# Service Bulletin

## Reinforcement Plate Installation on aircraft SB-LTUL-CTLS-13

Installation of Reinforcement Plate in upper attachment points of 4-point Harnesses.

Fig. 3-3-1-1 (View from luggage compartment)

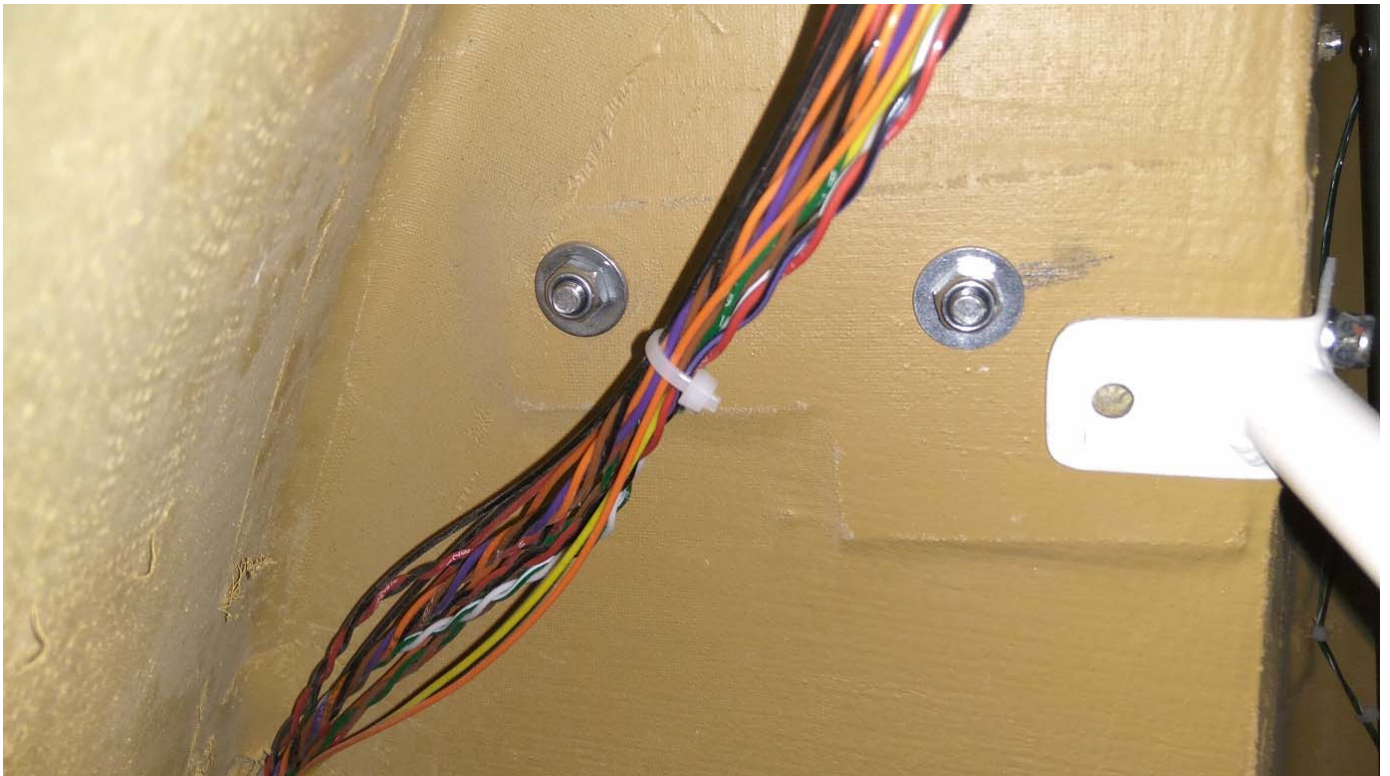
##### 3.3.1 Uninstall upper attachment point of Pilot Safety Belts.

Fig. 3-3-2-1.

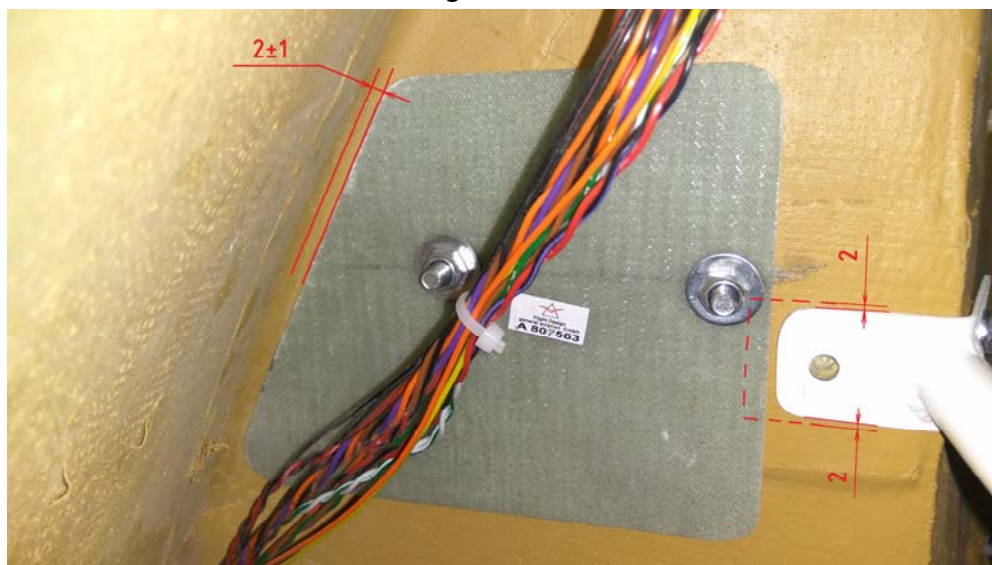
1. Position the plates according to the sketch on the frame. Mark the hole position. In case the plate overlaps with the parachute rescue system bracket attachment, mark and cut out a notch or trim the plate to give the correct placement. See Fig. 3-3-2-1.
2. Drill the 6 mm holes according to the markings.
3. Make a test installation and verify that the plate has correct position and a minimized gap to the frame.
4. Make final installation according to the Sketch 1.

Fig. 3-3-3

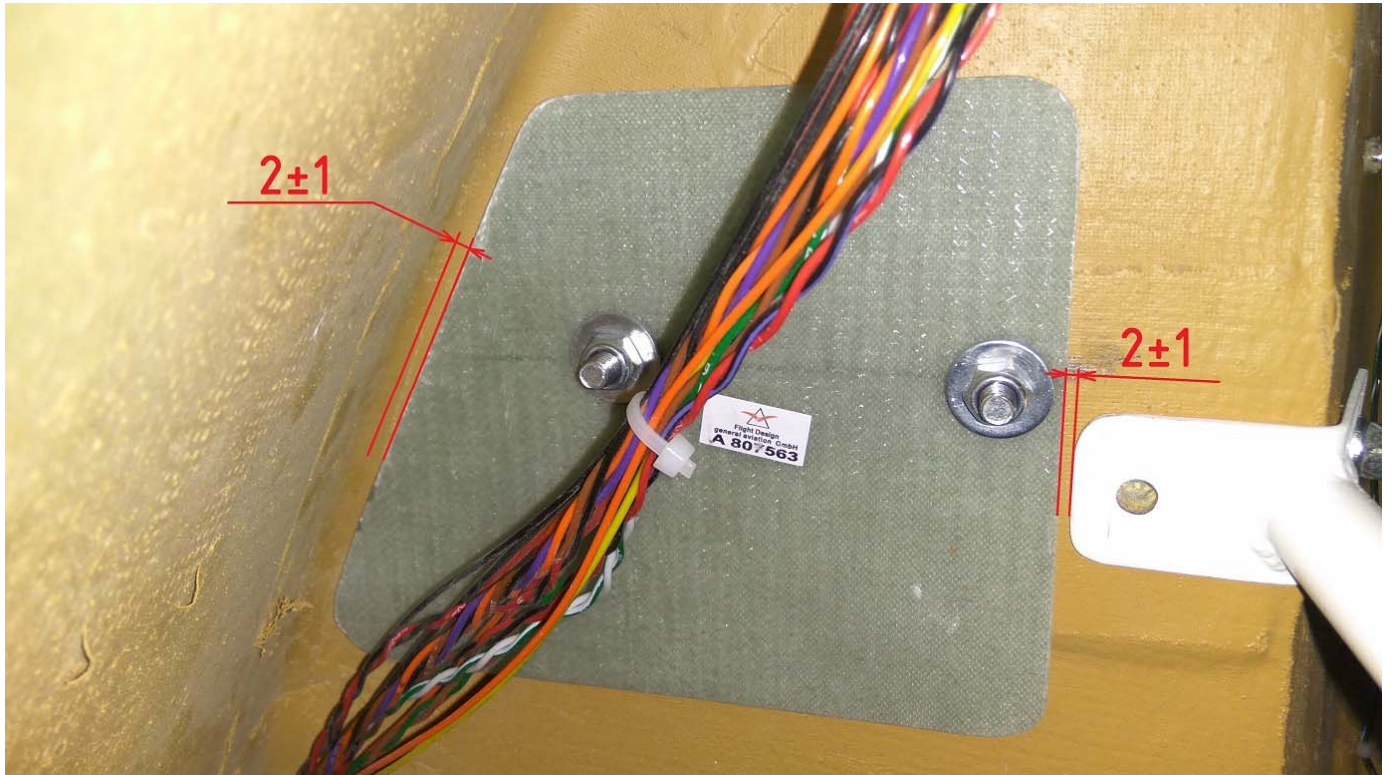
Mark all bolt-nut connections with "Paint Maraflored TK 36 red" or equivalent torque stripe.

Tightening torque nuts: 9Nm.
